PEER REVIEW REPORT

**PETERBOROUGH MEMORIAL CENTRE  
STRUCTURAL REVIEW**

C018.2148

FOR: CITY OF PETERBOROUGH | DATE: NOVEMBER 9, 2018

SK02 - PMC - SOFFIT INVESTIGATION PLAN

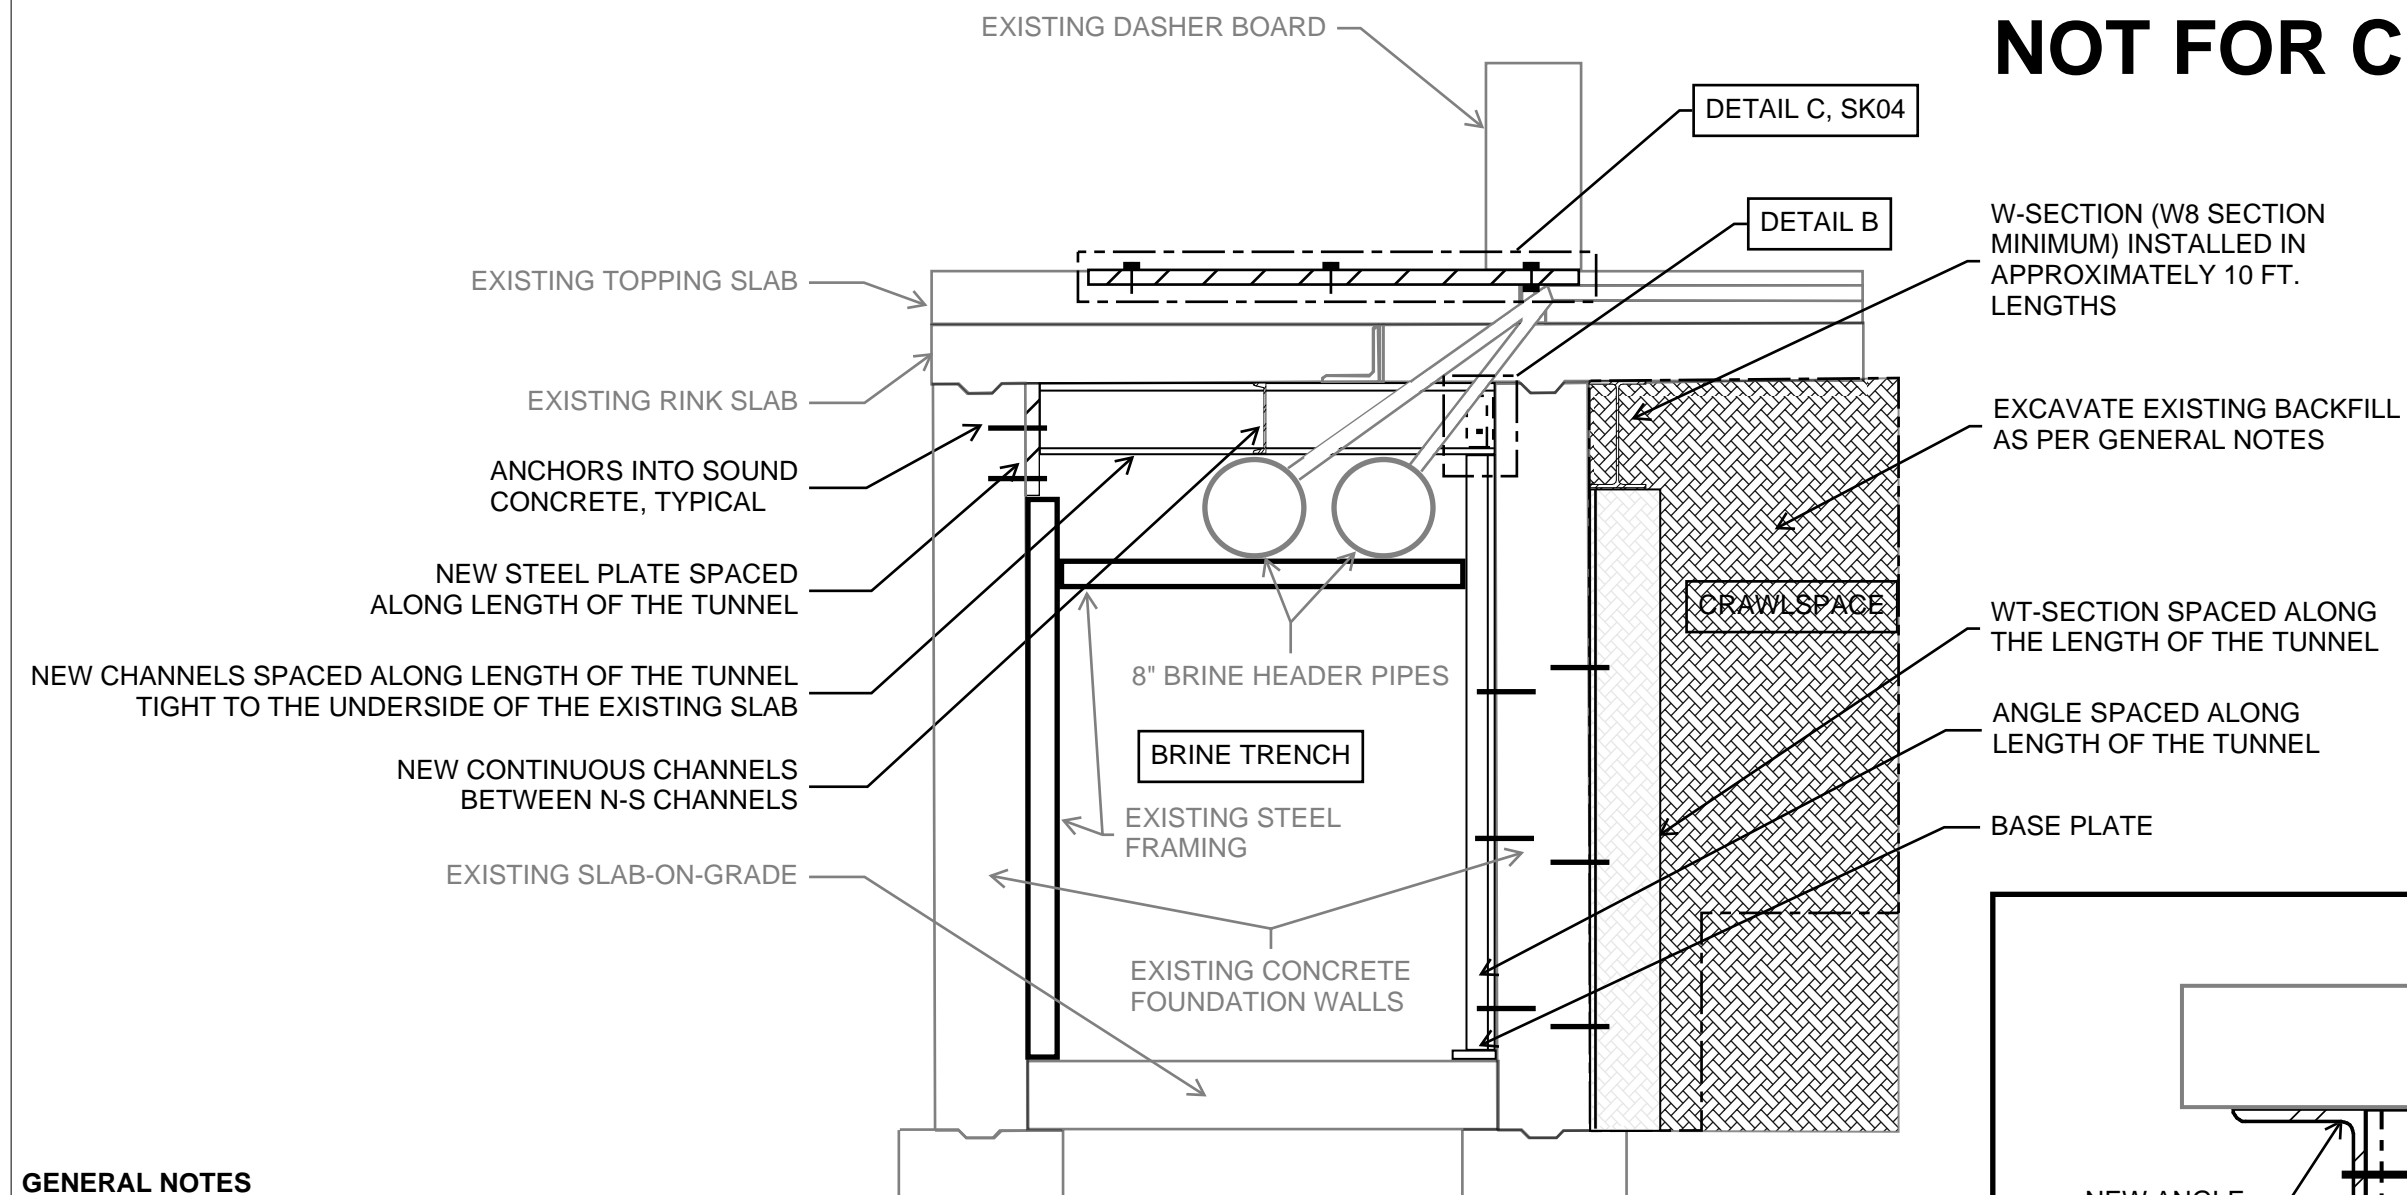
3. Based on our visual observations and our review of the existing drawings and the investigation reports to date, the condition of the suspended concrete slab beneath the ice resurfacers path at the southeast corner of the ice rink is in poor structural condition and should be repaired. Extensive cracking, delamination and spalling of the underside (soffit) of the original 1955 rink slab was observed, and wide cracks were observed on the topside of the 1979 topping slab directly above this deteriorated area. We recommend that through slab concrete repairs be completed in this location as soon as possible. Given that this area is outside the ice rink area, the repairs can be done in the hockey offseason while still providing continued access to the rink slab during the lacrosse season. Drawing SK01 & SK02 in Appendix B indicate the area of the recommended through slab repair.

Project: Memorial Centre Structural Review				Project No.: C018-2148	No.: SK03
Design: -	Drawn: -	Checked: -	Date: 09 NOV 2018	Activity No.: -	Scale: N.T.S.
Subject: PRELIMINARY SHORING AT SOUTH FOUNDATION WALL				Reference: SK02

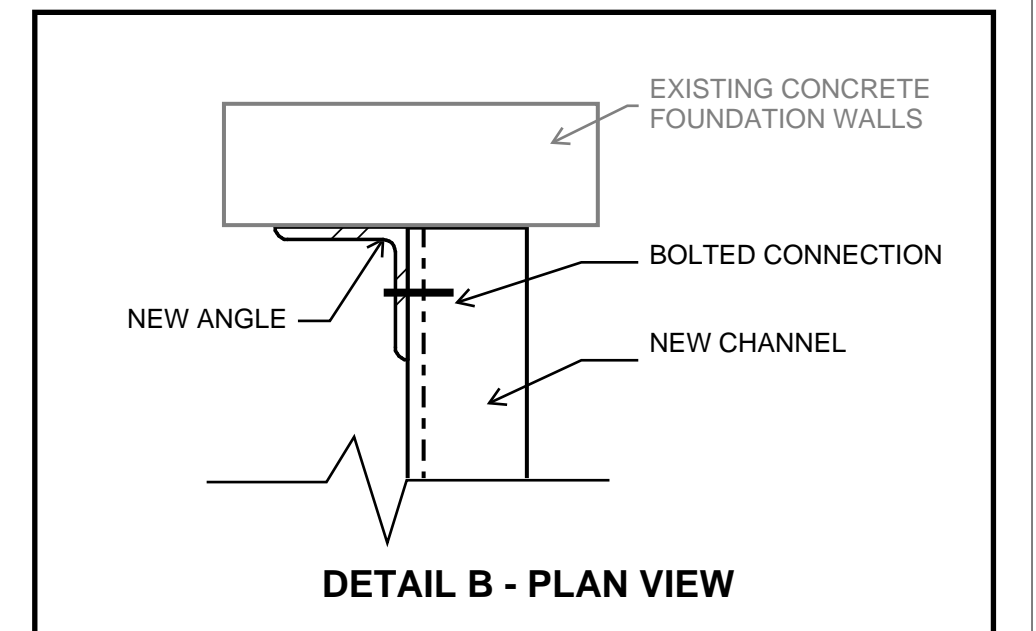
2. The localized deterioration of the rink slab along the length of the north brine trench foundation wall and the penetrations created by the new feeder pipes that were installed in approximately 1979, locally reduce the load carrying capacity of the rink slab structure. We recommend that steps be taken as soon as possible to provide additional support to the original rink slab and topping slab within the brine trench for the full extent of the north brine trench foundation wall. It is recommended that a steel frame support system be installed to transfer the loading back to sound concrete. A sketch detailing a proposed steel frame support system is included as drawing SK03 in Appendix B.

1. Under the “Summary of Findings” section on Page 4, CSE notes “The concrete foundation wall at the south end (below the dasher boards) of the rink was observed to be in poor to very poor condition. Concrete deterioration was noted over the full length of the wall. Under the “Comments & Recommendations” section on Page 5, CSE notes “The shoring being recommended is to fill the 1<sup>st</sup> cavity completely with a self-compacting backfill. Although it will not be possible to attain full bearing with the slab’s underside [soffit], the backfill will provide the required shoring to prevent any significant collapse of the rink slab and any associated health & safety concerns.” We agree with CSE’s assessment of the condition of the north foundation wall of the brine trench, but we question the effectiveness of the self-compacting backfill in the crawlspace. We are concerned that this recommended shoring approach presents too much risk to the client. It is highly probable that there is a void between the self-compacting backfill and the underside (soffit) of the original slab. As a result, little to no bearing is likely transferred to the backfill. We would recommend steel framing in this location, as shown in drawing SK03 in Appendix B.

3. In lieu of a concrete wall repair procedure, it is our recommendation that a steel frame support system be installed to transfer the load from the slab to sound concrete at the bottom portion of the existing foundation wall and footing. A sketch detailing a proposed steel frame support system is included as drawing SK03 in Appendix B. The proposed steel framing will have to be installed during the summer months when ice buildup is not present on the brine header and feeder pipes. The existing slab will bear on steel sections that run perpendicular (north-south) to the trench foundation walls. These steel sections will have a slim profile and will be spaced to accommodate the brine headers and feeder pipes to ensure that the existing brine system is not modified during the work or after the work has been complete.
